MEMORANDUM

Re: Tri-County Regional Vocational High School  
Con-Com and Peer Review Response 06/27/24

SCI File # 52033.02

June 27, 2024

**“A-series” Wetland Overflow in Existing (left) and Proposed (right) at 25-year (top) and 100-year (bottom) Storm Events**

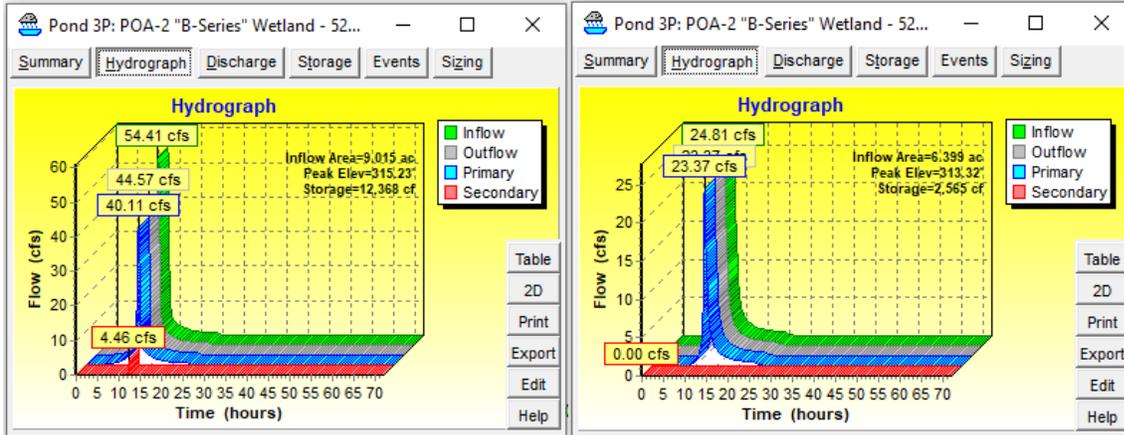
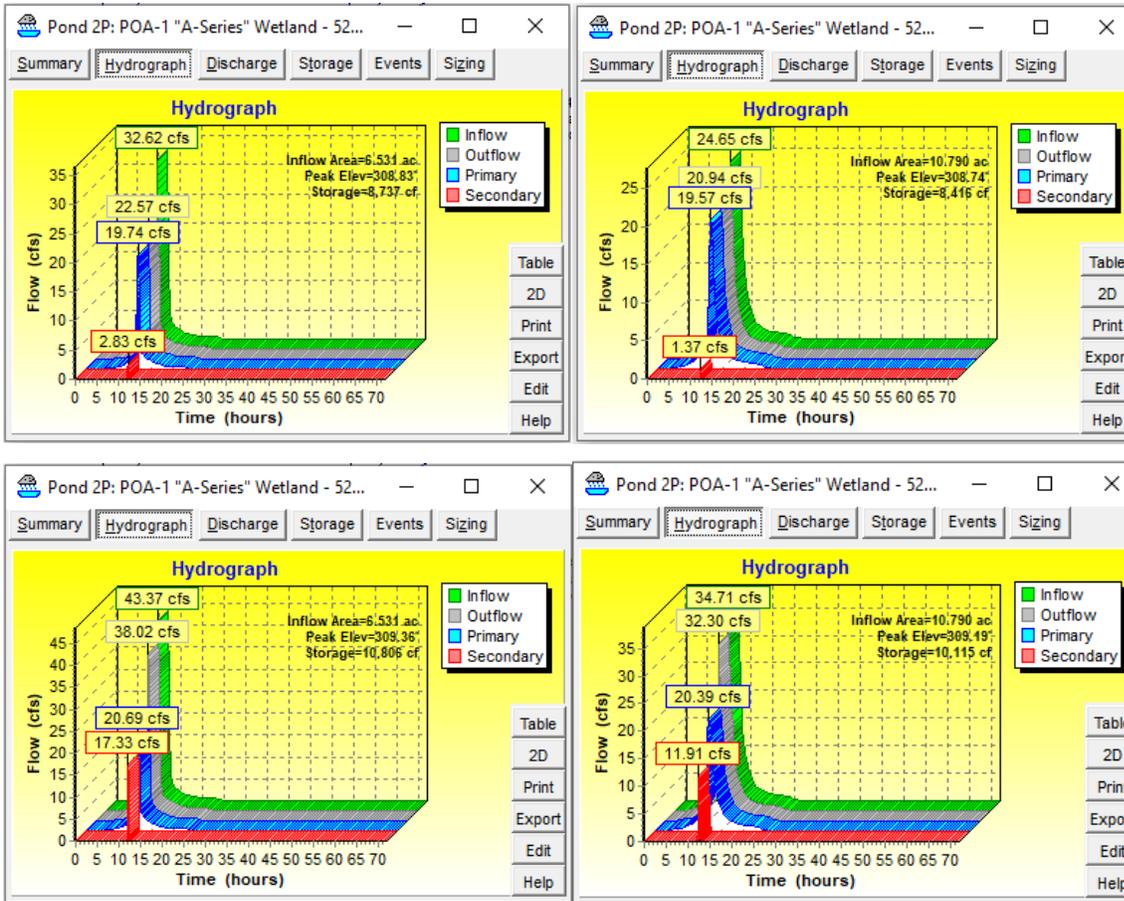
**BETA2: The provided tables show an increase in runoff volume to POA1, POA-2, POA-3, and POA-7. These points of analysis represent the “A” and “B” Series wetlands as well as the two Tri-County Drive closed drainage systems. The HydroCAD model has been revised to model the “A” and “B” series wetlands as ponds which serve to demonstrate how these low-lying areas will be impacted by the increased runoff volume. Both wetlands are shown to flood under both existing and proposed conditions, but flooding is increased under post-development conditions resulting in greater overland flow onto Tri-County Drive. Excess stormwater will be directed to the Tri-County Drive system.**

An increase in volume in the post-development condition at POA-1, POA-3 and POA-7 is unavoidable due to site constraints, including soils with very limited infiltration capacity. By adjusting the Stormwater Management design by connecting the discharge from BMP-4 to the 36" RCP located within/adjacent to Tri-County School Drive rather than directing flow to the B-Series Wetland, the post-development runoff volume to this wetland system will be maintained below pre-development values.

As previously discussed, the storage volume provided in the stormwater management design will flatten the peak rates of runoff at POA-1 and POA-3 for the 2-, 10-, 25- and 100-year storm events. Thus, more volume will pass through these points of analysis over a longer period of time, but at lower peak rates. In addition, by directing flow from BMP-4 away from the B-Series Wetland, the model shows that stormwater will no longer overtop the B-Series Wetland to the A-Series Wetland during the 100-year storm event. This will, in turn, reduce the amount of stormwater that overtops the A-Series Wetland to POA-7 in the 100-year event, mitigating the post-development peak rate of runoff to be less than pre-development conditions for this storm event. Through conversations with the Commission, it has been confirmed there have been no reports historically from the School and Town about flooding issues in these on-site or downgradient areas. Therefore, it is reasonable to infer that the slight increases in rate for the 2-, 10-, and 25-year storm events directed to POA-7 can be managed by the existing drainage systems within Tri-County Drive and Old West Central Street. The newly paved and curbed access drive is estimated to add an additional 2.2 cfs to the existing drainage system for the 25-year design storm per the rational calculations. It should be noted that the access drive is being upgraded to 20 feet wide to meet National Fire Protection Association (NFPA) standards. The current gravel drive has a much smaller width and does not meet current standards.

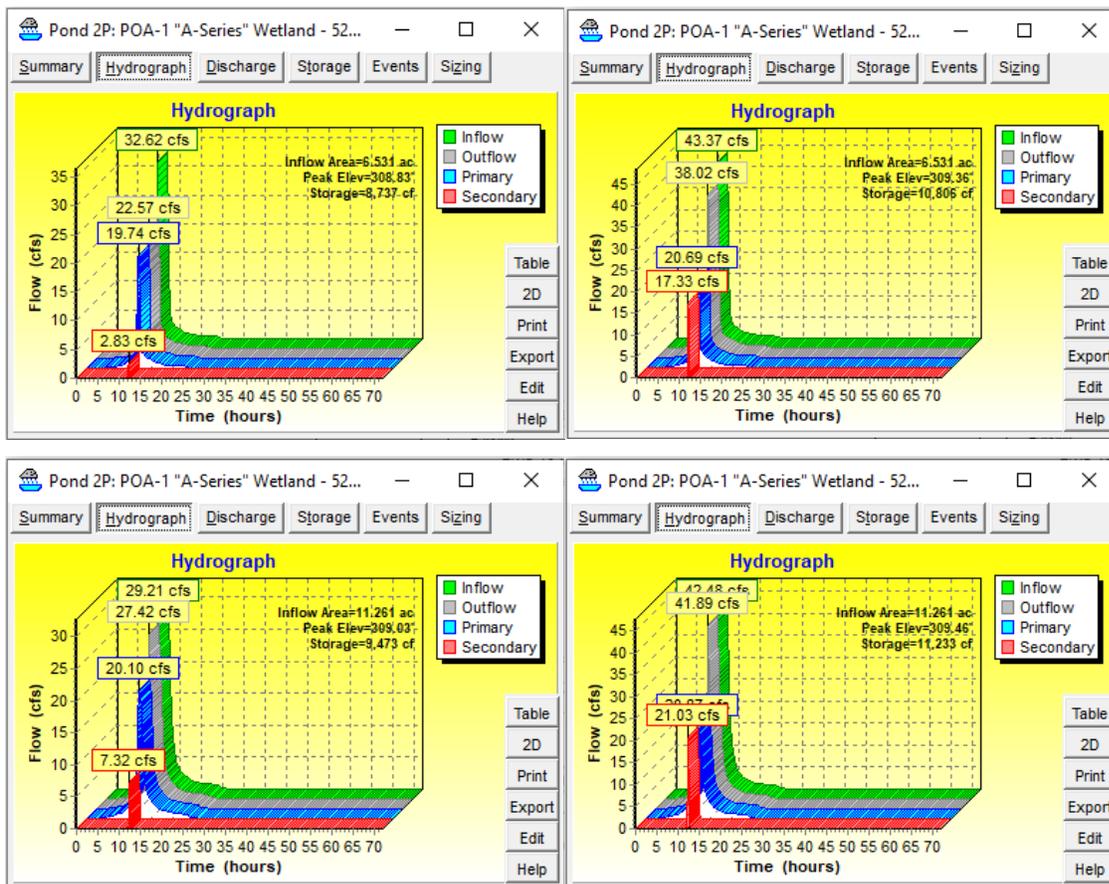
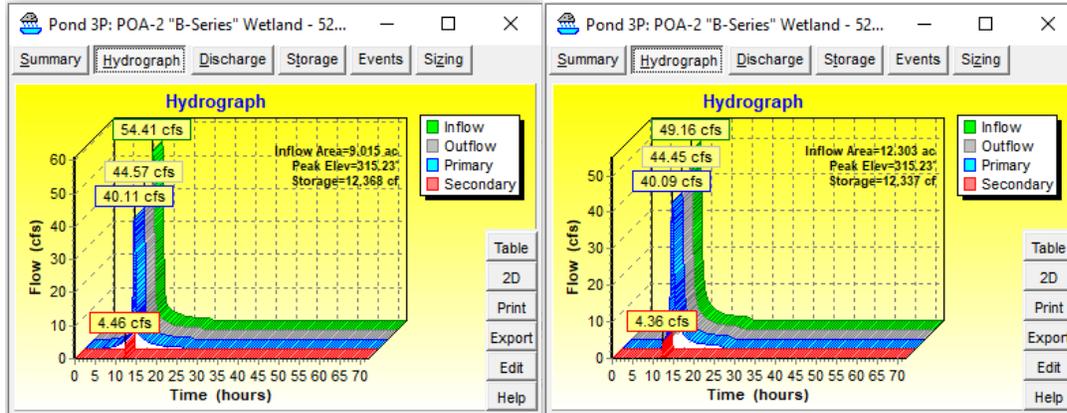
SW31. Provide table comparing pre- and post-development runoff volumes for each watershed area to evaluate flooding impacts to wetland resource areas and downgradient properties.

*SCI: Refer to Response to Comment SW16 for table comparing pre- and post-development runoff volumes for each watershed area. To evaluate the impacts for increasing volumes to the “A-series” and “B-series” wetlands, the wetlands were included as Ponds in both the existing and proposed HydroCAD models. Given the surface contours and volume available at each wetland, the model shows some overtopping at the “A-series” wetland in the existing condition at the 25- and 100-year storm events. Reviewing existing topography, theoretical runoff that overflows from the “A-series” wetland appears to run down the vegetated slope alongside Tri-County Drive to the inlet upgradient from the existing access drive. Any flows that do not get captured by the inlet appears to be directed on to Tri-County Drive or continue down and alongside Tri-County Drive. In the proposed condition, it appears that runoff will overtop the “A-series” wetland also during the 25- and 100-year storm events, but to a greater degree than existing. “A-series” Wetland Overflow in Existing (top) and Proposed (bottom) at 25-year (left) and 100-year (right) Storm Events*

*For the “B-series” wetland, the model appears to show that the runoff overtops the wetland in both the existing and proposed conditions at the 100-year storm event. The runoff that overflows from the wetland is slightly less in the proposed condition. “B-series” Wetland Overflow in Existing (left) and Proposed (right) at the 100-year Storm Event*

*For the additional runoff directed to the 12” RCP in Tri-County Drive, the pipe capacity was evaluated and no conflicts were found per the hydraulic rational calculations provided within the stormwater report appendices.*
